RE: 473 Wraight Avenue

I reviewed the drawings and evaluated the site context. My comments and recommendations are as follows:

PROPOSED FRONT ELEVATION

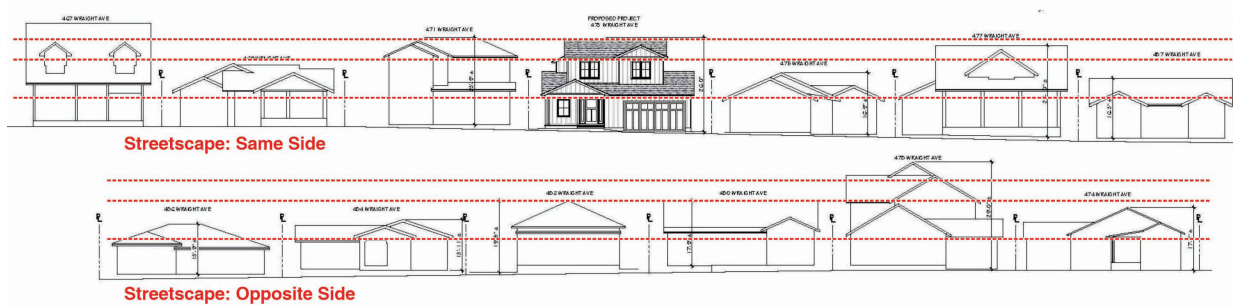
The proposed project is modest in scale with a height, bulk and articulation similar to other homes in the immediate neighborhood - see streetscape illustration below.

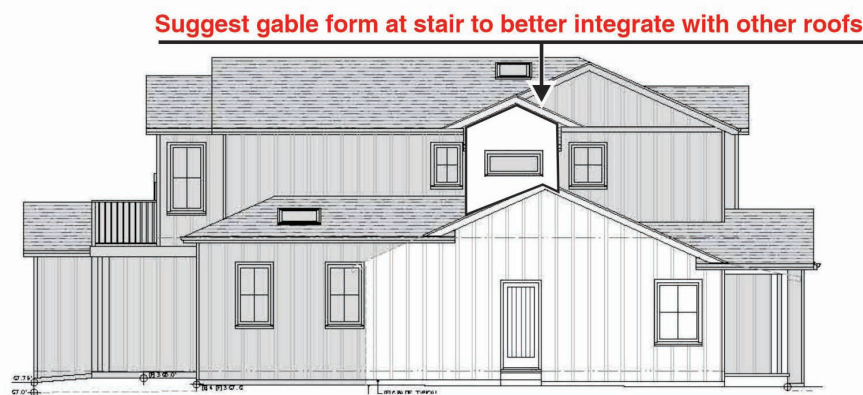
1. The shed roof form on the stair seems inconsistent with the predominant roofs.

Recommendation: Utilize a gable roof form over the stair in lieu of the shed roof as a way to better integrate it with the major roof forms.

2. The two car garage is flush with the front facade while other homes in the immediate neighborhood have detached garages set well back from the front facade or have only a one car wide garage door which is not consistent with Residential Design Guidelines 2.4.1 and 3.4.1.

Recommendation: Recess the garage door and add a trellis above the door - see Los Gatos examples below.

**Suggest gable form at stair to
better integrate with other roofs**

**Recess garage door and add trellis per
Residential Design Guideline 3.4.1**
